OPEL MANTA 2.0 E

VDT-I-OPE 019 En

L-Jetronic 2nd. generation.

Drawing 2

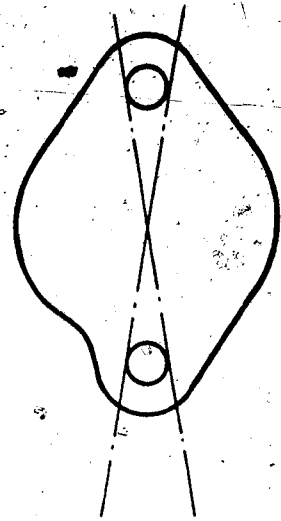
Correct the start of injection (advanced adjustment) in the starting range by fitting a modified timing-device cover with a 2 mm collar. Conversion can be carried out without removing the fuel-injection pump.

The cover (see drawing 2) can be uses-fabricated as follows:

Fig. 6

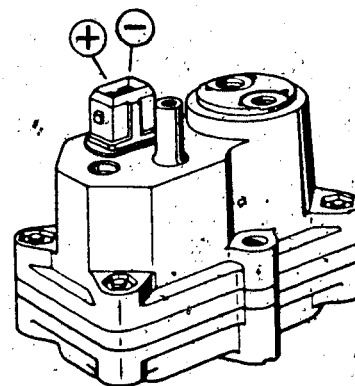
In the case of warm-up regulators with a thermo-contact it is absolutely essential to ensure the correct polarity of the electric connector. Incorrect connection will cause irreparable damage to the thermo-contact.

On the 928/928 S vehicles of model years 1978 to 1980 the correct polarity is not specified. Therefore, this must be tested when installing the new warm-up regulators and must, if necessary, be corrected on the connector (+ to +, - to -).

Modification of the wiper drive

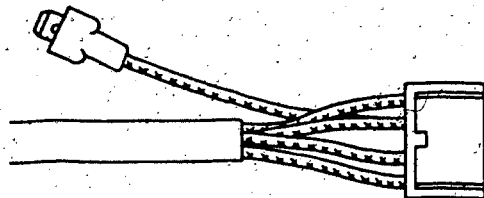
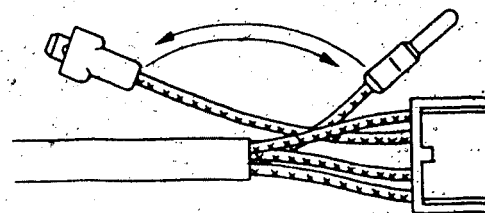
During the course of 1980 the wiper drive 3 397 020 072 was changed to .. 098 in the original equipment of the Renault R 4. The modification concerns only the plug-connection cable of the wiper motor, whereby the part number of the wiper motor is changed from 0 390 236 001 to .. 002.

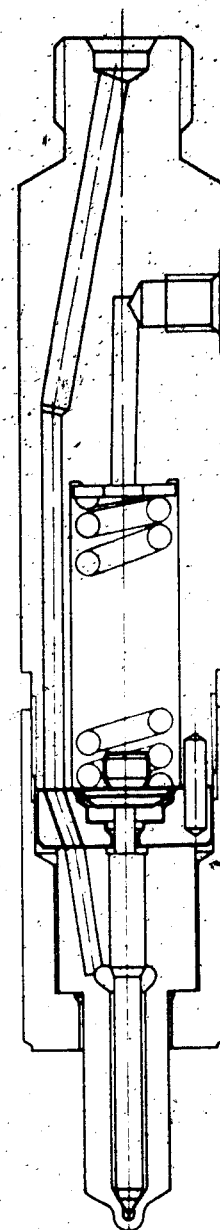
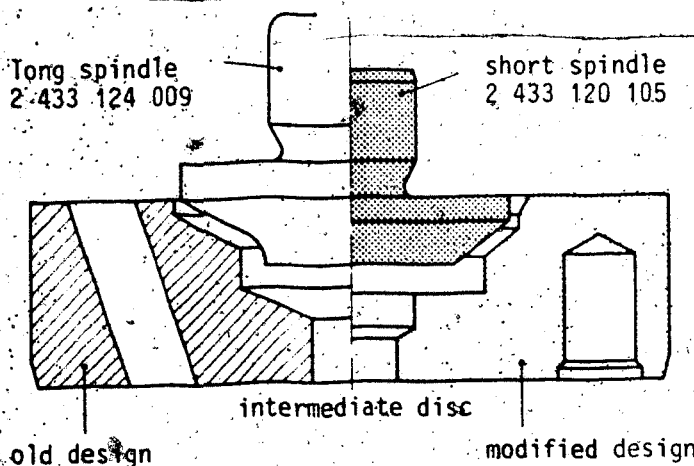
On various occasions pintle breakage occurred with
nozzle holder assemblies up to FD 824.

Starting with FD 825 this nozzle holder assembly will
be manufactured with shorter spindle 2 433 120 105
instead of 2 433 124 009 and modified intermediate
disc 2 430 136 078.

The new, short spindle 2 433 120 105 can only be used
with the modified intermediate disc.

The old, long spindle 2 433 124 009 can be used both
with old and modified intermediate disc.

The old, non-modified intermediate disc can only be
used with the long spindle 2 433 124 009.

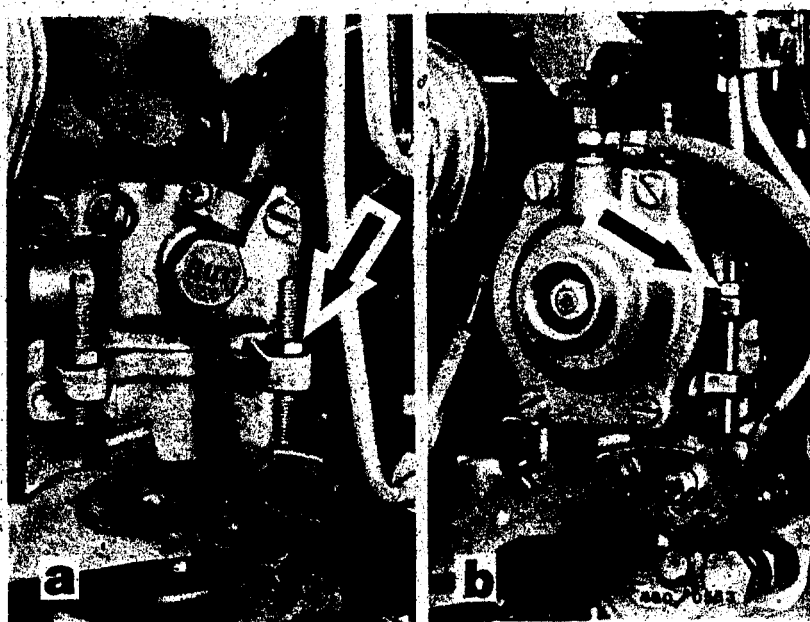
The cause is a change of the setting dimension of 12.7 mm measured between fulcrum lever and ball head of the TLA after the setting of the low idle speed.

Using caliper gauge, set distance between ball head and control lever to 12.7 mm.

Fig. 1 Old design

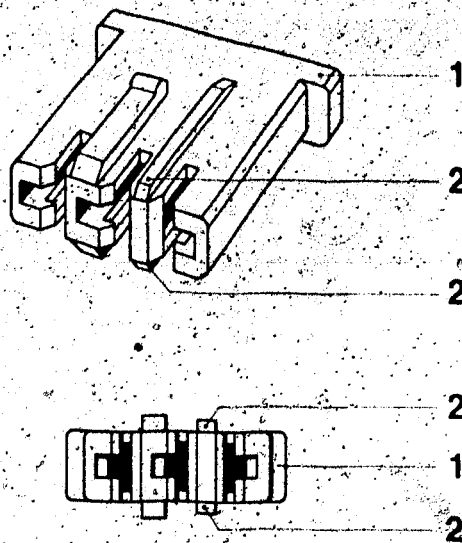
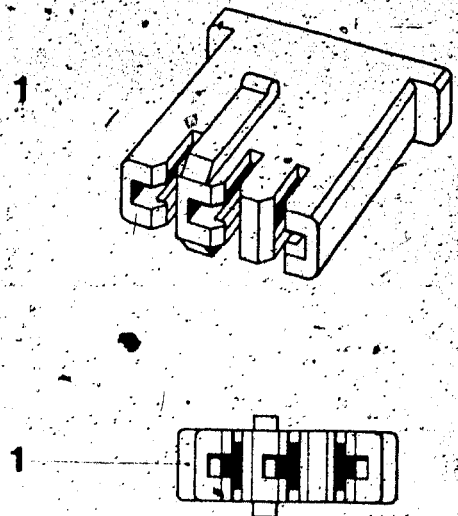
Since October 1980 modifications have been made to the ignition-distributor connector and the plug housing on Volkswagen vehicles. This means that in the case of replacements the new ignition distributor (with new plug housing) can no longer be connected to the old distributor connector (vehicles with wiring harness).

Using a file, carefully remove the two long narrow guide noses on the ignition-distributor connector - old design (Fig. 1).
Please note: The new distributor connector fits into both the old and the new ignition-distributor plug-housing.
